Notice of Allowability

10/779,831

SWIFT, EDGAR LEON

EXAMINER'S AMENDMENT

Fig. 4

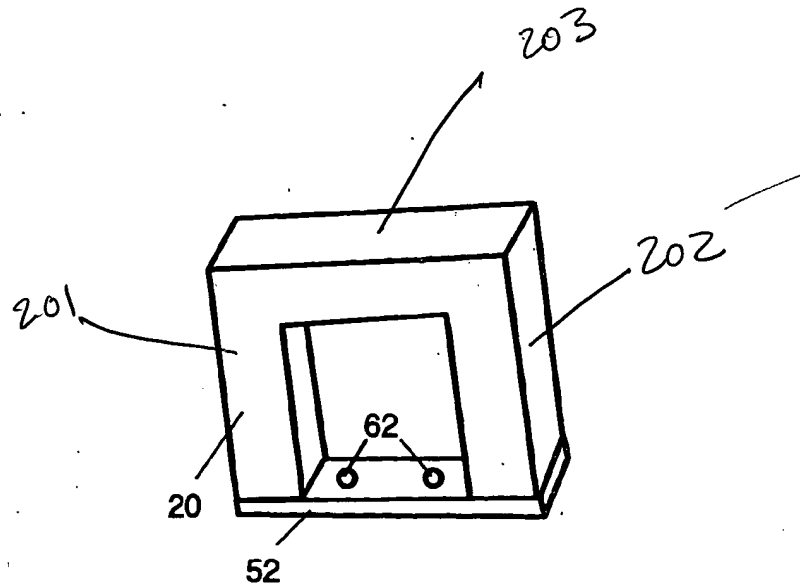
- in line 5-6 from the bottom of pg. 11 of the specification the phrase "uprights 20 and (22 shown in Fig. 4)" has been changed to --uprights 22 and (20 shown in Fig. 4)-- to coincide with what is illustrated in the figures.

2. The following changes to the drawings have been approved by the examiner and agreed upon by applicant: the following element numbers have been added to figure 4 "201" and "202" to represent the upright portions and "203" to represent the handgrip

portion. See attached revised figure 4. In order to avoid abandonment of the application, applicant must make these above agreed upon drawing changes.
